Staff Report

Re: 10141 Hwy 17 – Dollar General parking lot resurfacing – TMS 764-00-00-515

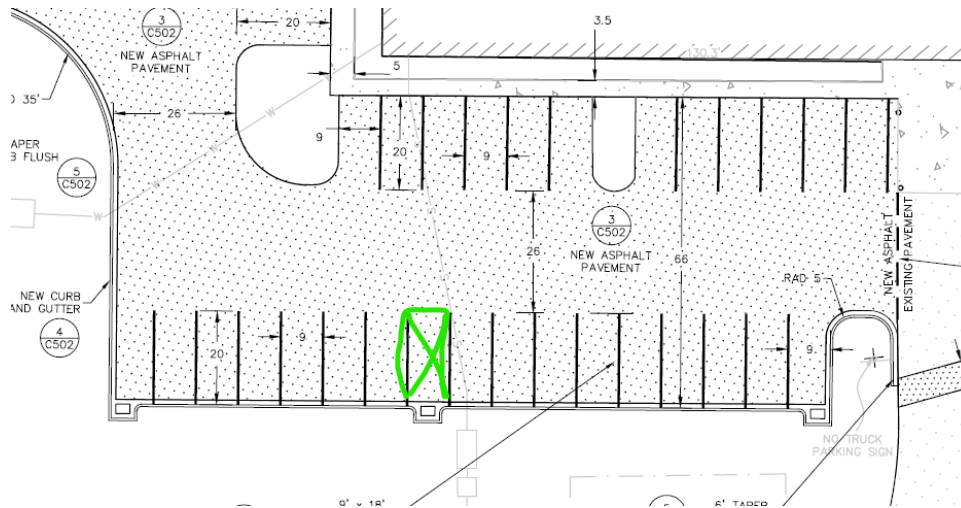
The plans dated 10/29/24, submitted by Forsberg Engineering, fail to recreate the original and required parking island identified below on the outer bay of parking closest to Leland Creek Rd, which has been compacted and now being used as a parking space. Different sets of plans show slightly different locations of the septic lines and the actual location will need to be confirmed. Some show it where located on this plan and others in the adjacent parking space closer to Hwy 17. It would not be recommended to provide the island where the septic line runs due to tree roots and also the drain box location would be rendered nonfunctional if the island were put in front of it so some fine tuning will be needed to this plan with the island and the tree planted in the island. This parking island location has some flexibility in location as its placement needs to break up the parking such that no more than 10 spaces are in a row and shall be required to have a shade tree, two shrubs and be protected from vehicles per section 8.8.3. Additionally, the plan fails to provide information towards a vegetation survey so it is unknown what existing landscaping will be removed or adversely impacted as a result of the

drainage work, but it is evident the present plan will require many removals which will require replacement if unavoidable. The tracks of the machine to install the pipe run will likely cause damage or removal to the line of shrubs and trees parallel to Leland Creek Rd however the 20' deep parking spaces can be reduced to 18' (section 8.6) which may help some once the vegetation is shown on the plans.

Staff is supportive of the overall project however will need additional information concerning vegetation impacts, the parking island being provided and any associated engineering revisions resulting from these with alternate silt fence and tree barricade locations to be provided.
